**Pier 26 Upland Park Construction – Landscape and Irrigation
Project/Contract #C4891-D
Addendum # 3
December 3, 2018**

3. Attachment A of the RFP contained in the Project Manual is hereby amended as follows and as specifically set forth in Attachment 1 herein:

(A) "1. C4891 –A-E Pier_26 Upland Park Construction" is amended to include the following drawing modifications:

PAVING & DECKING PLAN - PIER A

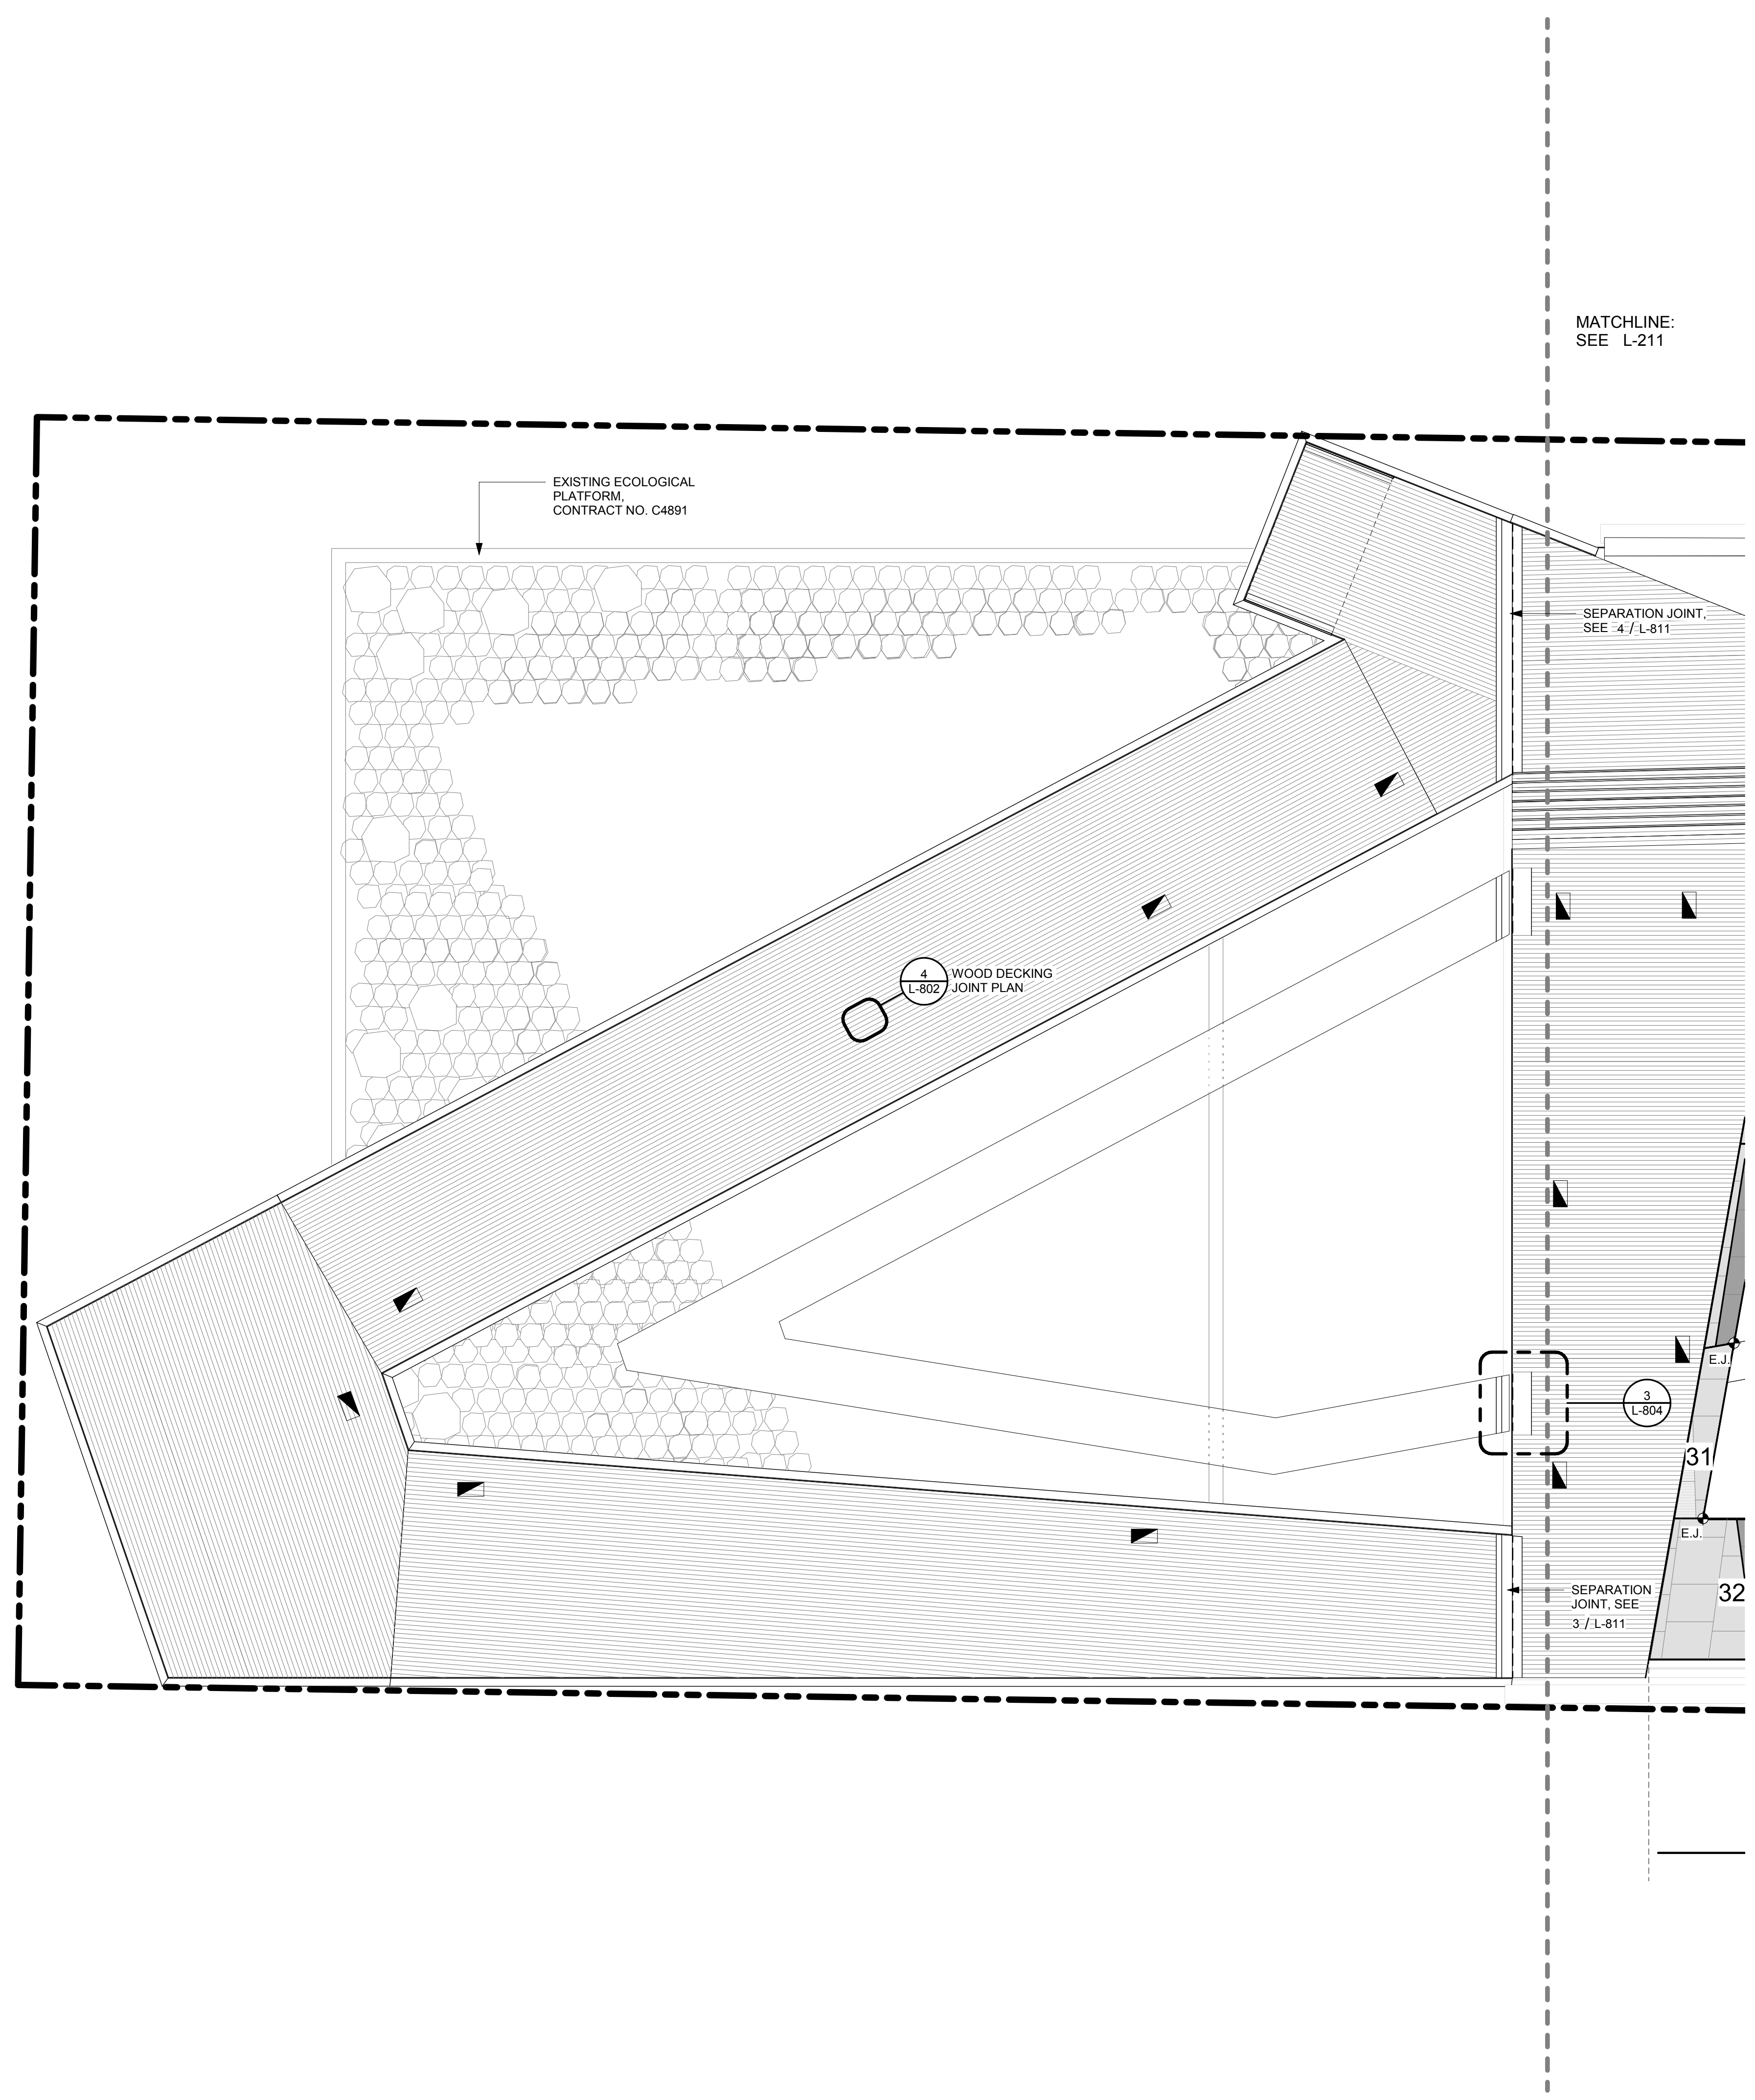
Drawing	Update
L-210-DECK SUBSLAB LAYOUT&GRADING PLAN - PIER A	Topping slab description clarified.
L-230-PAVING& DECKING PLAN- PIER A	Legend corrected to say inlaid finish, instead of sandblast inlaid finish.
L-231 - PAVING & DECKING PLAN - PIER B	Legend corrected to say inlaid finish, instead of sandblast inlaid finish.
L-232 - PAVING & DECKING PLAN - PIER C	Legend corrected to say inlaid finish, instead of sandblast inlaid finish.
L-233 - PAVING & DECKING PLAN - PIER D	Legend corrected to say inlaid finish, instead of sandblast inlaid finish.
L-234 - PAVING & DECKING PLAN - NORTH UPLAND	Legend corrected to say inlaid finish, instead of sandblast inlaid finish.
L-243 - PAVING MODULES	The unique shell inlay material has been removed.
L-400 - GRADING PLAN - PIER A	Symbol for slot drain and trench drain has increased visibility.
L-401 - GRADING PLAN - PIER B	Symbol for slot drain and trench drain has increased visibility.

GRADING PLAN - PIER C

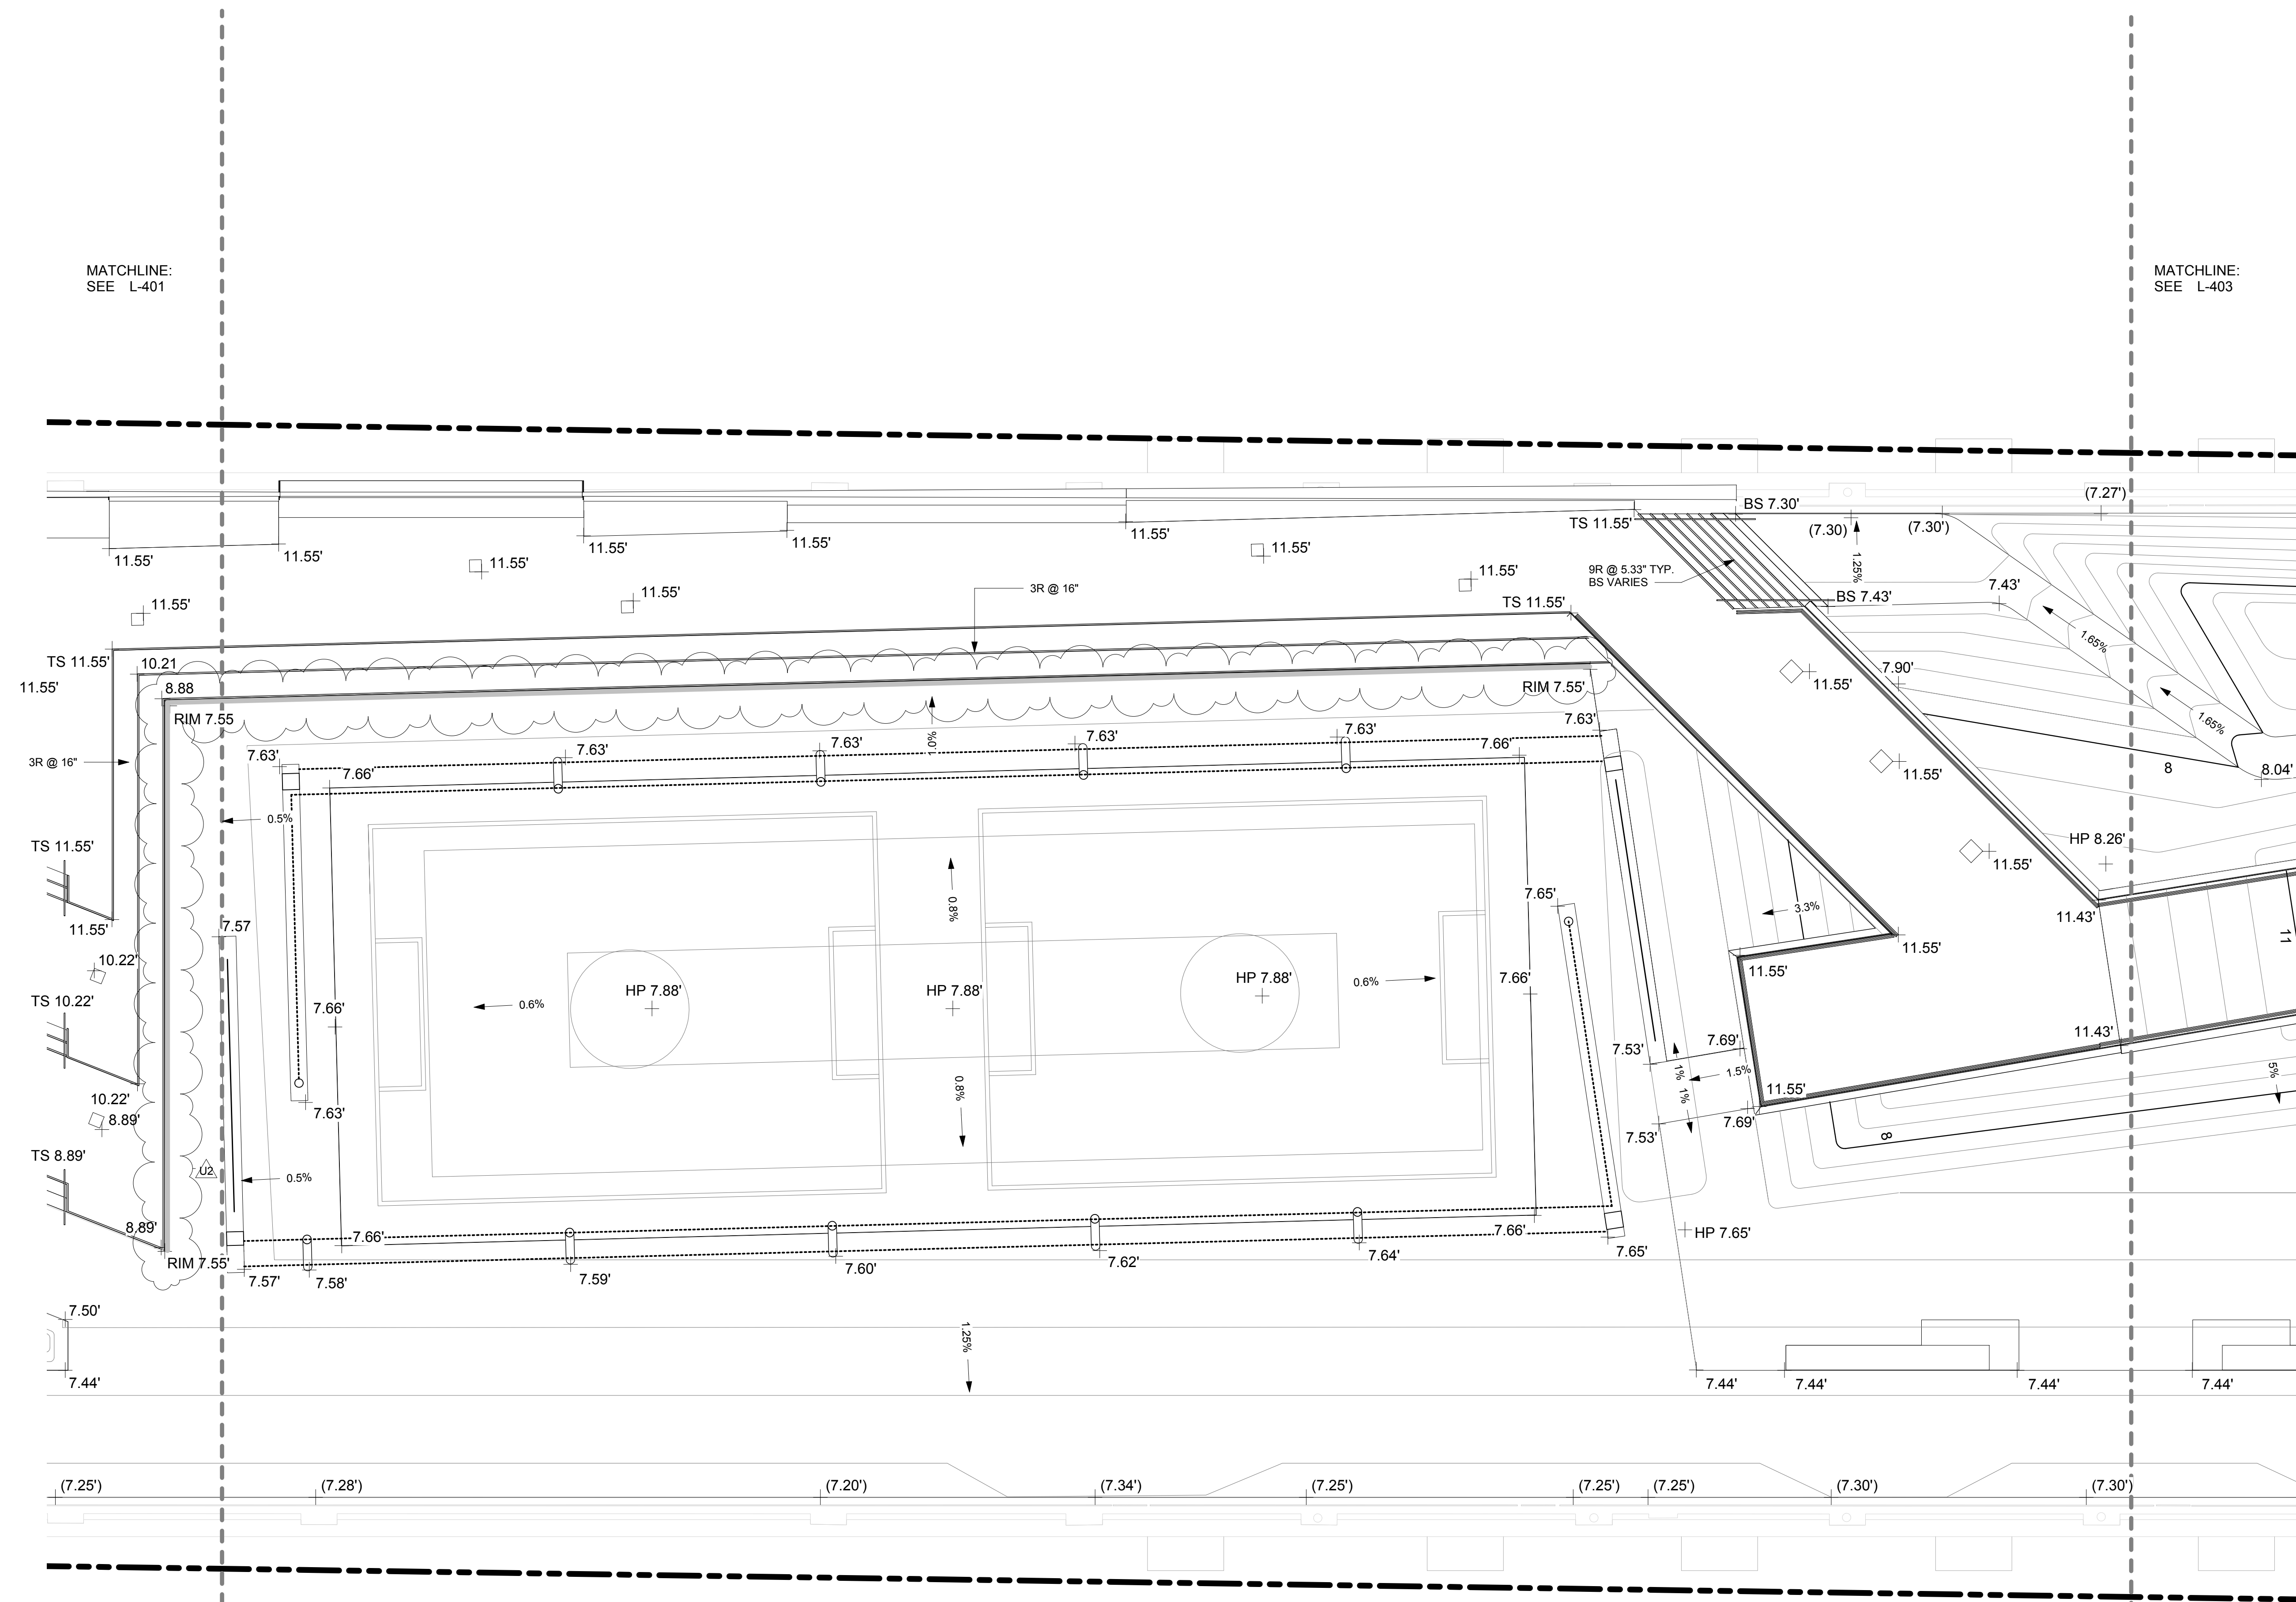
L-402 - GRADING PLAN - PIER C	Symbol for slot drain and trench drain has increased visibility.
L-403 - GRADING PLAN - PIER D	Symbol for slot drain and trench drain has increased visibility.
L-404 - GRADING PLAN - NORTH UPLAND	Symbol for slot drain and trench drain has increased visibility.
S-301 - FRAMING PLAN - PIER B	Walkway south of seating terrace no longer called out as 8" concrete seating step.
S-302 - FRAMING PLAN - PIER C	The thickness of the concrete is correctly labeled to show the 8" depth only at the 15' wide southern, as in the materials plans.
E-301 - ELECTRICAL PLAN - PIER B	Location of Q-vault shown.
E-302-ELECTRICAL PLAN - PIER C	Electrical clarification to sport pole.
E-308 - WOOD AND STEEL SHED ELECTRICAL DETAILS.pdf	New sheet showing clarifications of electrical work at the sheds.
P-303 - SANITARY PIPING PLAN - PIER D	Cross section of piping added.
P-312 - SANITARY PIPING PLAN - PIER C	Clarification to boat service utilities.
